## SUBMITTAL SUMMARY REPORT MajorSite-000232-2026

<b>PLAN NAME:</b> Belleview Substation	<b>LOCATION:</b>
<b>APPLICATION DATE:</b> 01/09/2026	<b>PARCEL:</b> 4217-223-000
<b>DESCRIPTION:</b> Application for Major Site Plan of a proposed electrical substation.

Re: Belleview Substation - MajorSite-000232-2026  
Waiver Request to Major Site Plan in Review  
PARCEL NUMBER: 4217-223-000

Drawing #  
**BV-02-126**

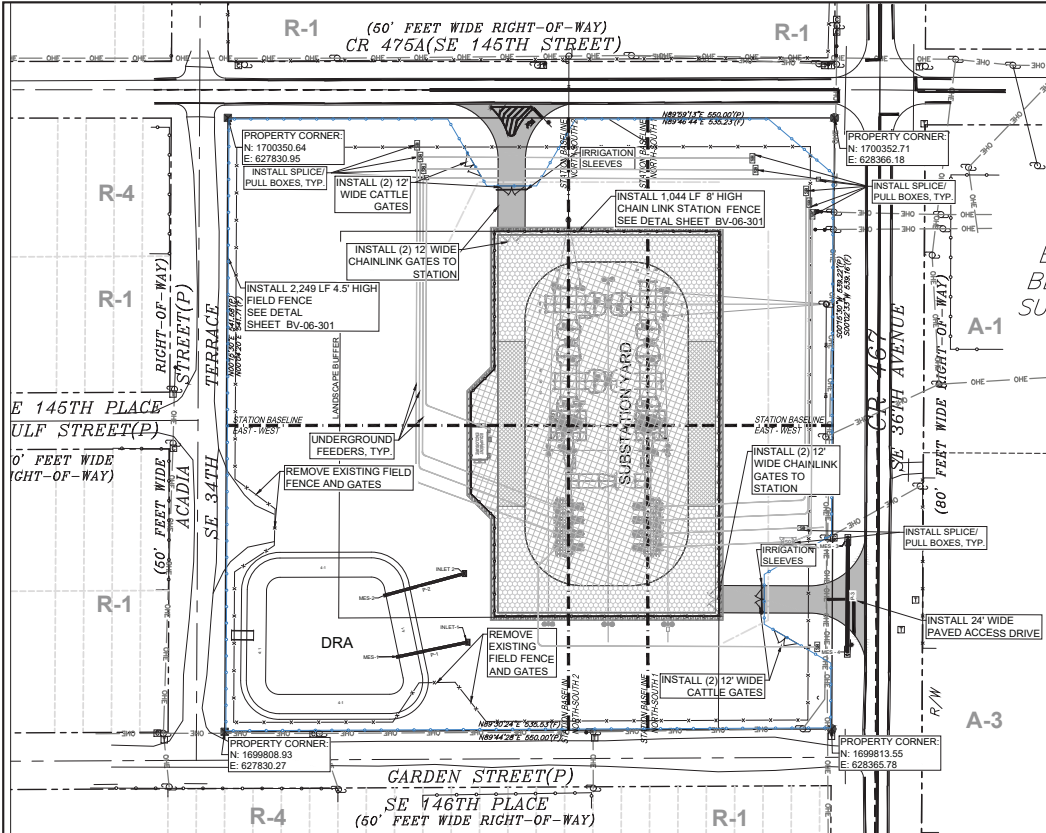
- Corrections** 2.12/4.2 - Lot setback (**Resolved**) - **Corrective Action:** Provided setbacks shown on BV-02-128 are not consistent with the provided setbacks listed on BV-02-126 Site Data table. East shown = 102 feet. West shown = 216 feet. Fractions over .5 were rounded up. - 2.12/4.2 - Lot setback: Provide required setback and proposed setback in the site data table and show them on the plan.
